Rainey Tower SPC-2021-0129C

January 19, 2022

Heritage Tree Variance Request

Tree structure (cont.)

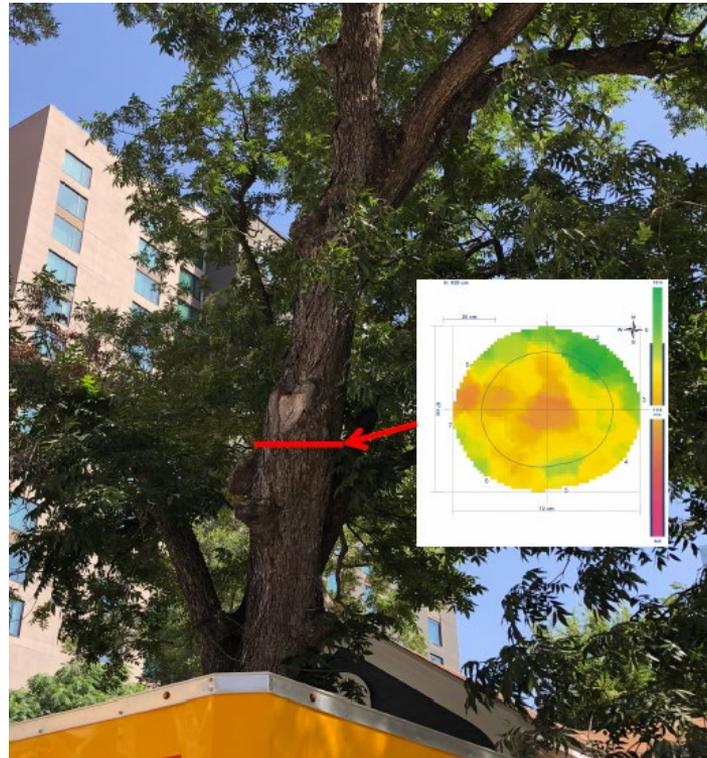
Horizontal and longitudinal cracks developing seven feet above grade. May be an imminent hazard within 5-10 yrs.
